Certified Action of the City of Raleigh Planning Commission

Case File / Name: SP-16-12 / Skyhouse Apartments

Staff Report

SP-16-12 Skyhouse Apartments – Preliminary Site Plan

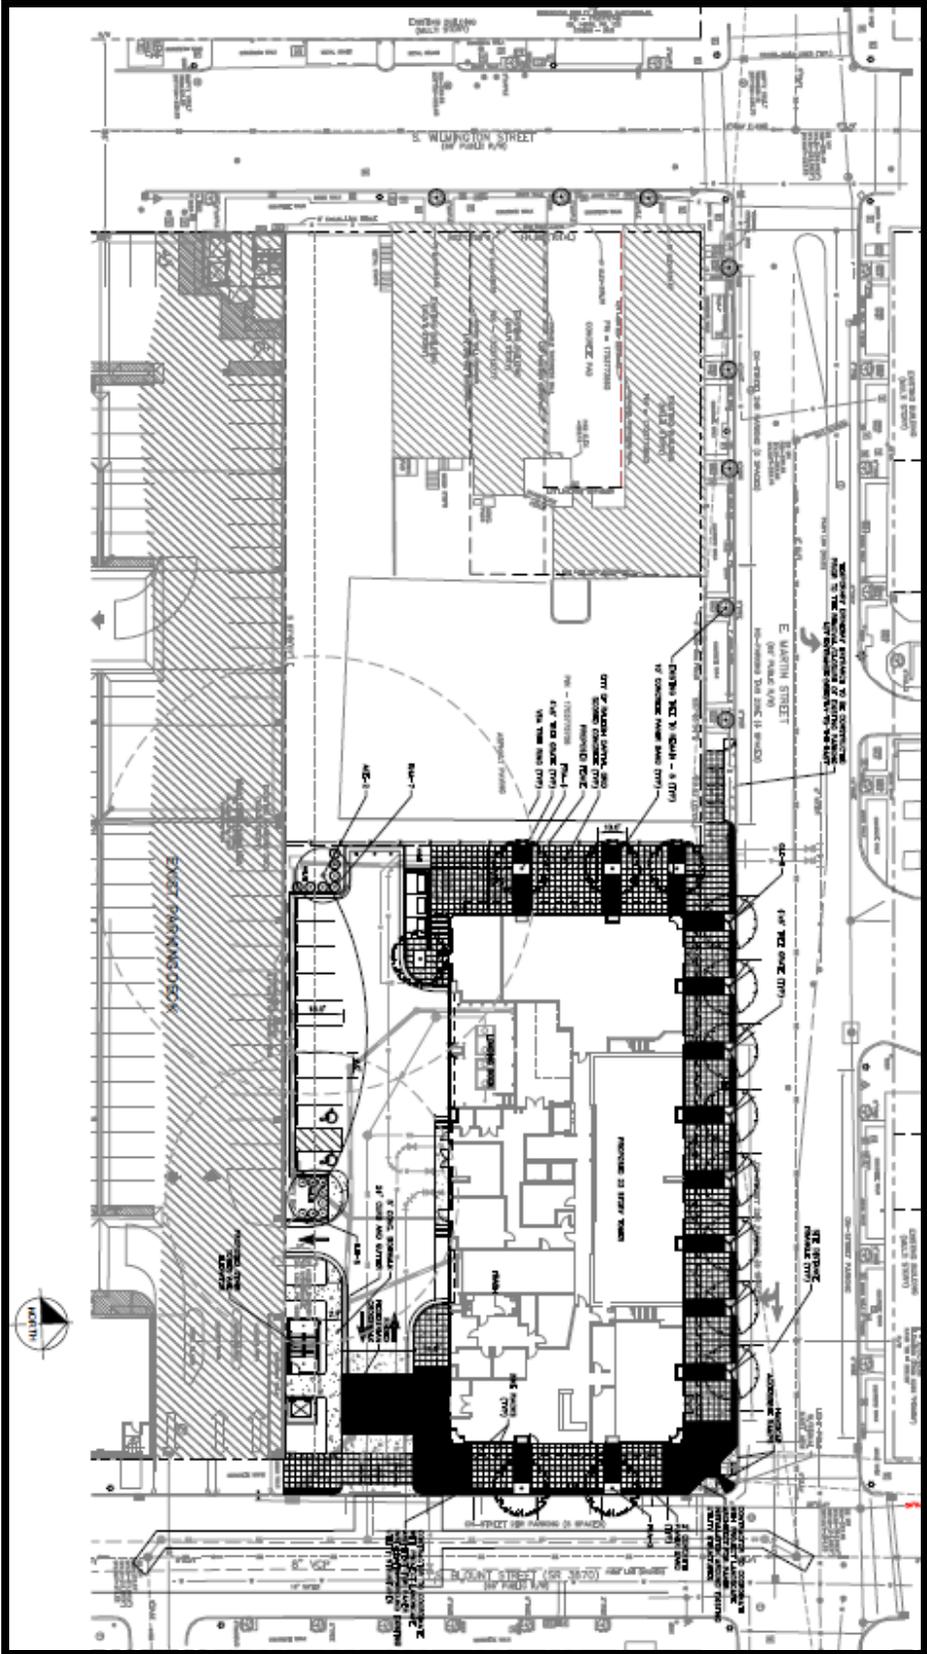
- (8) That the plans be revised to include landscaping in full conformance with 10-2082.6 including the installation of a visually modifying screen or barrier of plants, closed fences, walls, earthen berms or any combination thereof that meets the requirements of Section 10-2082.6 between sidewalk and the existing surface parking lot;

- (9) That the plans be revised to include a minimum of a 14' wide sidewalk along Martin Street except for those portions where existing buildings preclude it;

- (10) That the landscape plans be revised per the City's Urban Forester in the Parks & Recreation Department to reflect the following changes:
 - A. Change tree species to match the trees along the corridor. Trees selected for Blount Street shall be Red Oak (either Nuttal, Shumard or Overcup). Trees selected for Martin Street shall be Lacebark elm (*Ulmus parvifolia*, cultivar: Bosque).

- B. Increase the caliper size of the trees to at least 2.5".
 - C. Reduce the number of trees on Martin Street to be 35' on center. The proposed 20' on center is too close.

Vehicular surface area landscaping is not shown in conformity with Section 10-2082.6 in the area of the existing parking lot proposed to remain on site. A recommended condition of approval would require the installation of a visually modifying screen or barrier of plants, closed fences, walls, earthen berms or any combination thereof that meets the requirements of Section 10-2082.6 between sidewalk and the existing surface parking lot and the sidewalk.

- Downtown Urban Design Guideline #41 states "Buildings downtown and in Pedestrian Business Overlays should have stepbacks and articulated facades to mitigate wind effects and increase light and air. Buildings should step back 10 to

15 feet at the 60-foot point above the ground on a wide street and 15 feet on a narrow street. A wide street is 75 feet in width or more, and a narrow street is less than 75 feet in width.” The proposed building does not contain building setbacks. This is particularly important as the site is bordered by a local historic district to the north and east that features significantly smaller structures. A setback would help the proposed building relate to the adjacent properties as well as mitigate wind effects and increase access to light and air.

- Downtown Urban Design Guideline #3 states “Surface and structured parking should be landscaped, emphasizing interior tree canopies in surface lots, formal borders and street trees to reinforce the streetwall” The existing surface parking lot located mid-block on Martin Street is part of this site plan. As such, it should be improved commensurate with UDG 3.
- Downtown Urban Design Guideline #15 states “Recessed entries are encouraged.” The doors for the ground floor spaces (commercial space and lobbies) should be recessed to avoid pedestrian conflicts.
